# HISTORIC AND DESIGN REVIEW COMMISSION

**HDRC CASE NO:** 2018-379  
**ADDRESS:** 631 MUNCEY  
**LEGAL DESCRIPTION:** NCB 1301 BLK 2 LOT N 50 FT OF 8 & 9  
**ZONING:** R-5, H  
**CITY COUNCIL DIST.:** 2  
**DISTRICT:** Dignowity Hill Historic District  
**APPLICANT:** Justin Abt  
**OWNER:** Justin Abt  
**TYPE OF WORK:** Construction of a rear addition, roof replacement  
**APPLICATION RECEIVED:** July 13, 2018  
**60-DAY REVIEW:** September 11, 2018  
**REQUEST:**

A RESIDENCE FOR:  
**631 MUNCEY HOME ADDITION**  
631 MUNCEY  
SAN ANTONIO, TEXAS 78202

**NEW WORK FLOOR PLAN**  
SCALE: 1/4" = 1'-0"

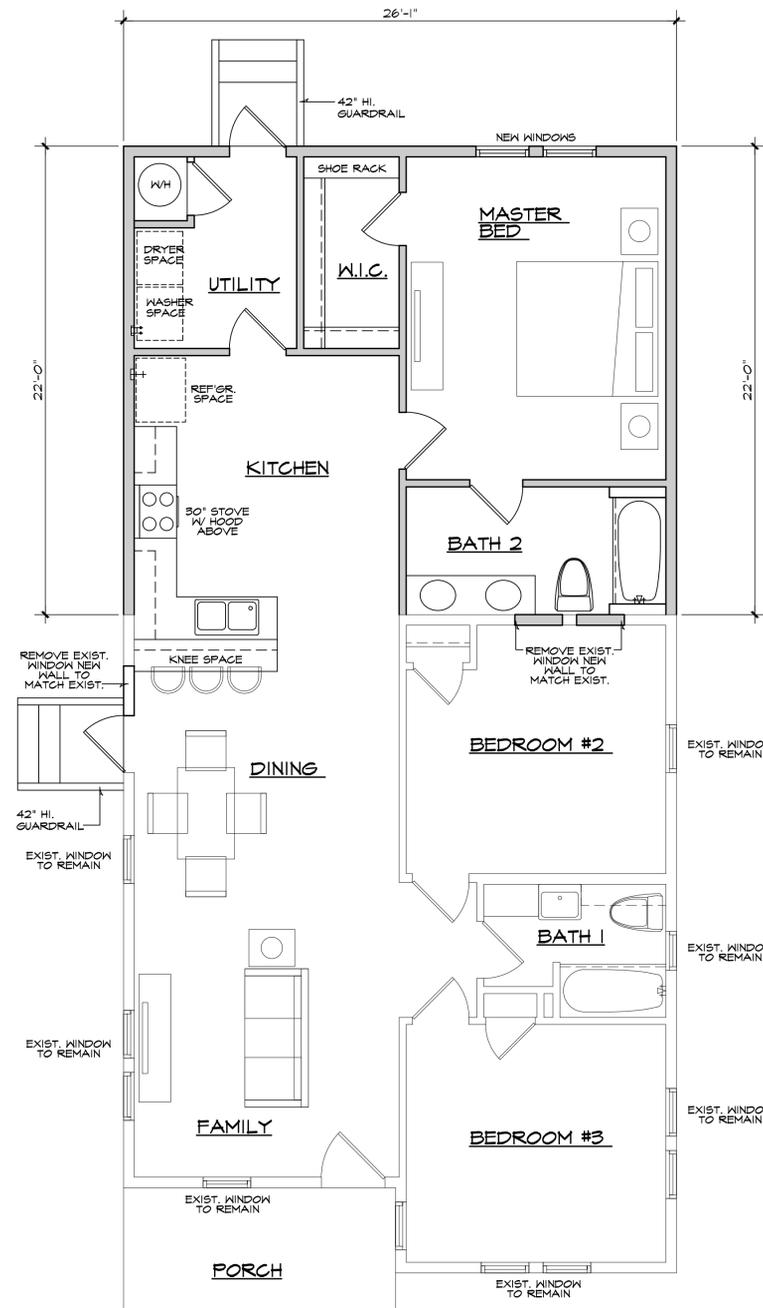
- b. ADDITION – The Guidelines for Additions 1.A. states that additions should be sited to minimize visual impact from the public right of way, should be designed to be in keeping with the historic context of the block, should utilize a similar roof form and should feature a transition between the old and the new. The applicant has proposed for the addition to feature a roof form that matches that of the historic structure and a vertical trim piece on each elevation to separate the addition from the historic structure.

- g. ARCHITECTURAL DETAILS – Generally, staff finds the proposed addition to be appropriate in massing and form. While the proposed addition is more than forty percent of the existing structure’s square footage, staff finds the proposed addition’s size appropriate for the size of the lot.

Staff recommends approval based on findings a through g with the following stipulations:

**NEW WORK REAR ELEVATION**  
SCALE: 1/4" = 1'-0"

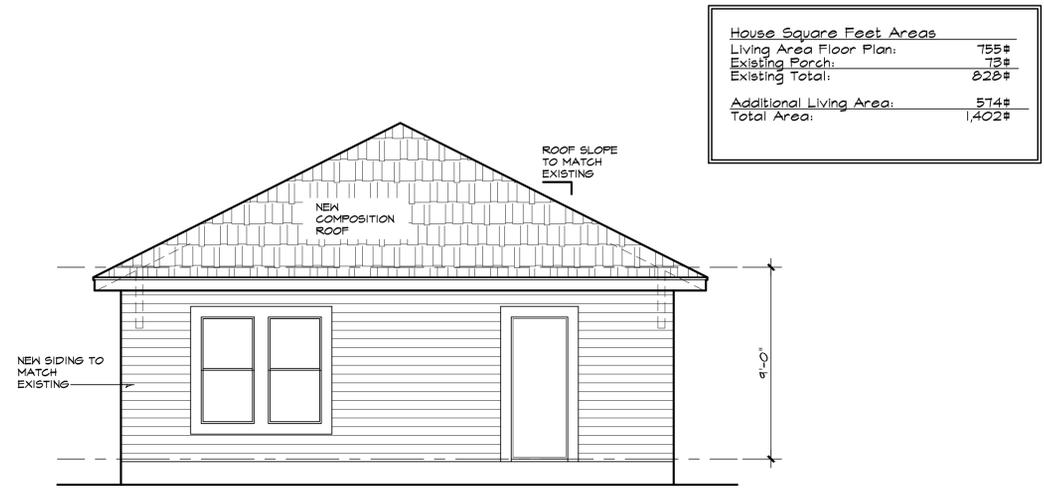
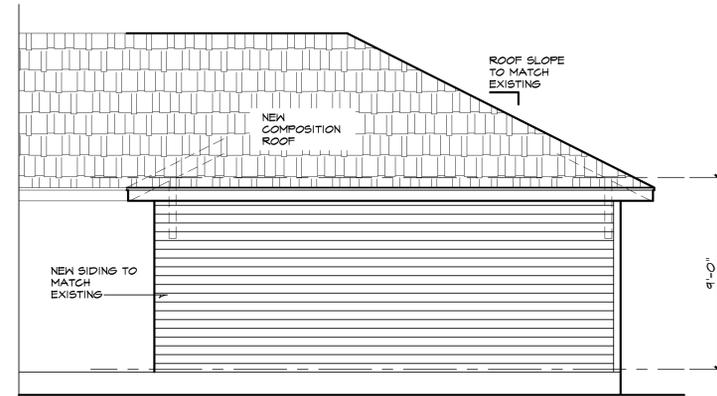
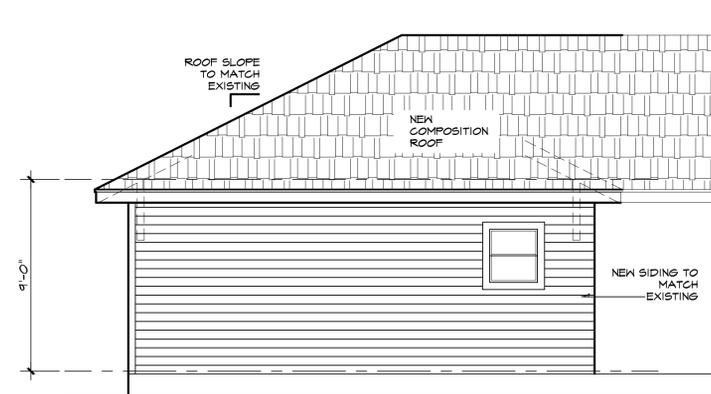
- c. ROOF FORM – The applicant has proposed for the addition to feature a roof form that is comparable to that currently on the historic structure; a gabled roof in the front with a hipped roof in the rear. The applicant has proposed to tie into the existing structure’s roof and extend the new roof with a matching ridge height to the rear of the addition.

- d. TRANSITION – As noted in findings b and c, the applicant has proposed to construct the rear addition in the same wall plane as the historic house as well as use the same ridge line. The reduction of the proposed addition’s ridge height or an inset in wall plane would be appropriate; however, staff finds that the proposed vertical trim piece is sufficient in separating the addition from the historic structure.

- e. MATERIALS – The applicant has proposed materials that include wood siding to match that of the existing structure, an asphalt shingle roof, and one over one windows. The structure currently features a standing seam metal roof; however, Craftsman structures located within the Dignowity Hill Historic District feature both shingle and metal roofs. Staff finds the roof replacement to be appropriate.

- f. WINDOW MATERIALS – At this time, the applicant has noted that aluminum windows that match those existing in the historic structure will be installed. Staff finds that wood or aluminum clad wood windows should be installed that feature meeting rails that are no taller than 1.25” and stiles no wider than 2.25”. White manufacturer’s color is not allowed, and color selection must be presented to staff. There should be a minimum of two inches in depth between the front face of the window trim and the front face of the top window sash. This must be accomplished by recessing the window sufficiently within the opening or with the installation of additional window trim to add thickness. Window trim must feature traditional dimensions and an architecturally appropriate sill detail. Window track components must be painted to match the window trim or concealed by a wood window screen set within the opening.

- i. That wood or aluminum clad wood windows should be installed that feature meeting rails that are no taller than 1.25” and stiles no wider than 2.25”. White manufacturer’s color is not allowed, and color selection must be presented to staff. There should be a minimum of two inches in depth between the front face of the window trim and the front face of the top window sash. This must be accomplished by recessing the window sufficiently within the opening or with the installation of additional window trim to add thickness. Window trim must feature traditional dimensions and an architecturally appropriate sill detail. Window track components must be painted to match the window trim or concealed by a wood window screen set within the opening.
